# **Addressing Delay, Skew, and Skew Variation**

**Comments: 77-96, 121**

P802.3cd Task Force  
November 2016

# 50GBASE-CR/KR/SR/FR/LR PMD skew and skew variation

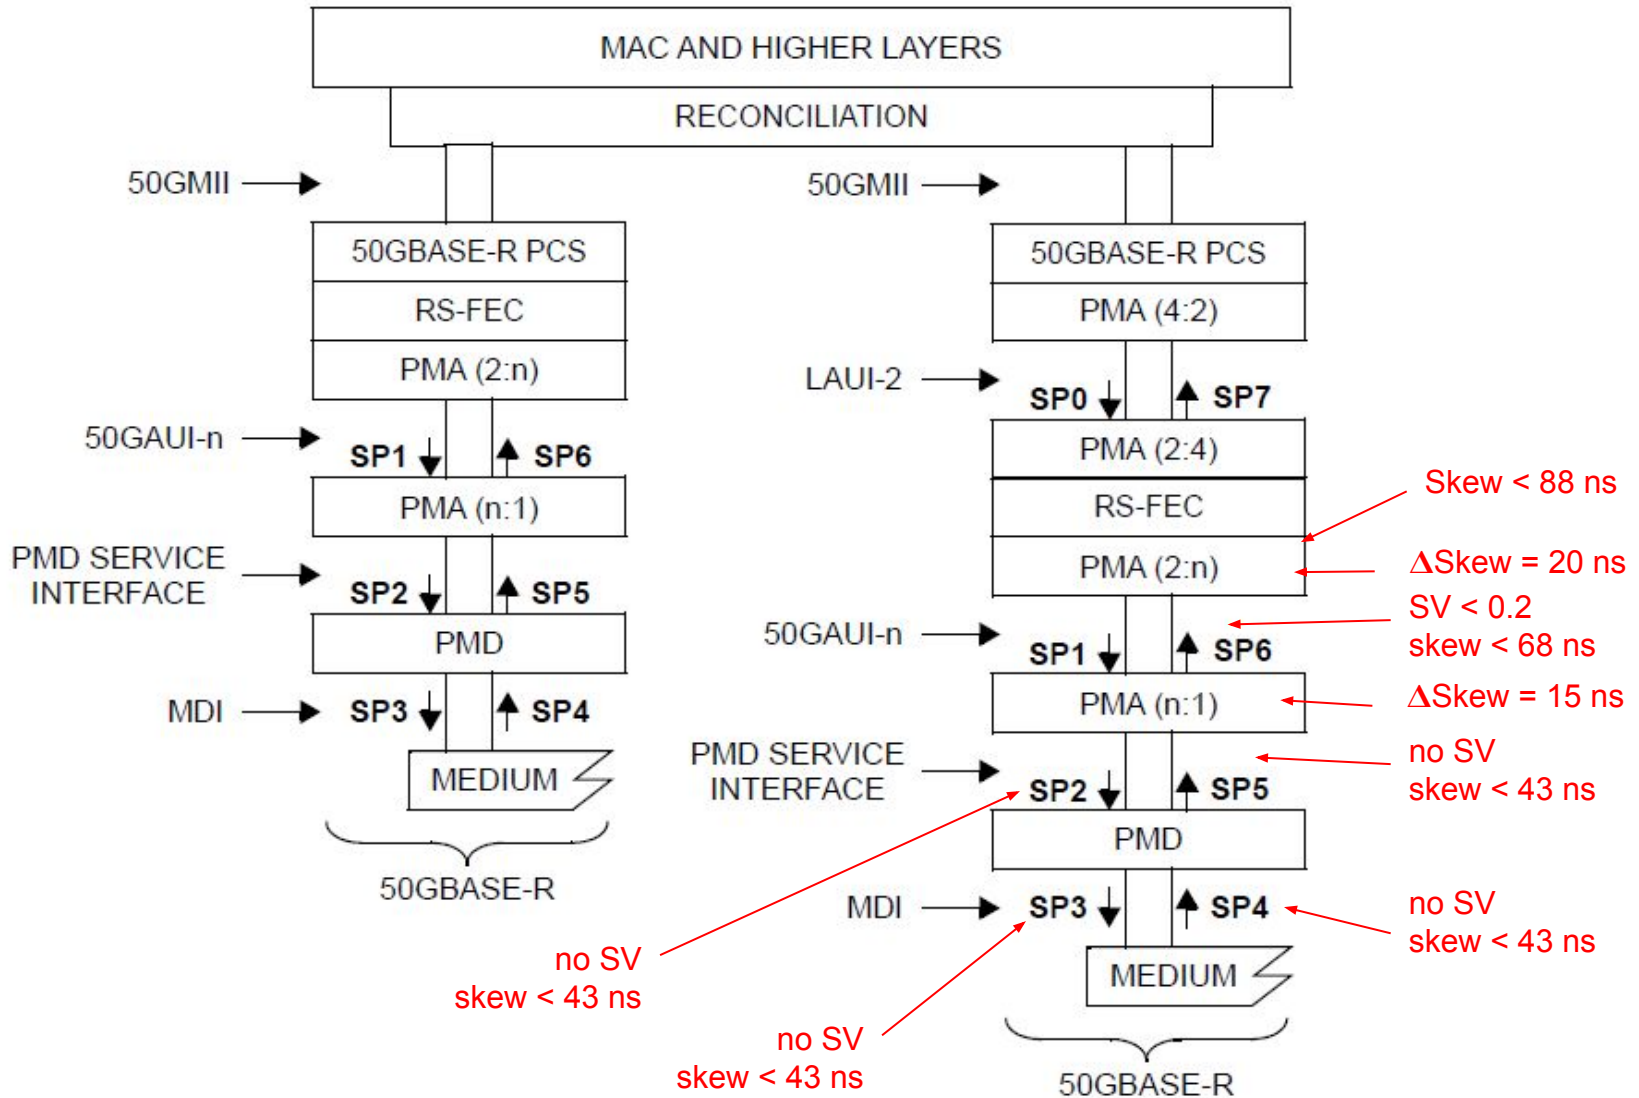
- It is proposed that we use values of Skew and Skew Variation already established for 40GBASE-R, 100GBASE-R, and 200GBASE-R with the following exception.
- For 50GBASE-R and 100GBASE-DR PMD the numbers are adjusted with the following considerations:
  - skew variation is zero at the PMD transmit input, transmit output, receive input, and receive output
  - there is no skew addition due to the PMD and the medium

Skew Points	40GBASE-R 100GBASE-R (ns)	50GBASE-*R 100GBASE-DR (ns)
SP0	29	29
SP1	29	29
SP2	43	43
SP3	54	43
SP4	134	43
SP5	145	43
SP6	160 (145+15)	68 (43+15)
SP7	29	29
at PCS Rx w/o RS-FEC	180	N/A
at RS-FEC Tx	49	49
at RS-FEC Rx	180 (160+20)	88 (68+20)
at PCS Rx with RS-FEC	49	49

Skew Points	40GBASE-R 100GBASE-R	50GBASE-*R 100GBASE-DR
SP0	0.2	0.2
SP1	0.2	0.2
SP2	0.4	0
SP3	0.6	0
SP4	3.4	0
SP5	3.6 (3.4+0.2)	0
SP6	3.8 (3.6+0.2)	0.2
SP7	0.2	0.2
at PCS Rx w/o RS-FEC	4	N/A
at RS-FEC Tx	0.4	0.4
at RS-FEC Rx	4	0.4 (0.2+0.2)
at PCS Rx with RS-FEC	0.4	0.4

- For 50GBASE-R, update the skew budget and skew variation budget in Clause 131 and the constraints in each of the relevant sublayer clauses according to the proposed values in Slide 17 and Slide 18, respectively.
- For 100GBASE-DR PMD update the skew to be 43 ns at SP2, SP3, SP4, and SP5
- For 200GBASE-\*R, PMDs and all other 100GBASE-\*R PMDs update the skew and skew variation constraints consistent with budgets in Clause 116 and Clause 80, respectively.
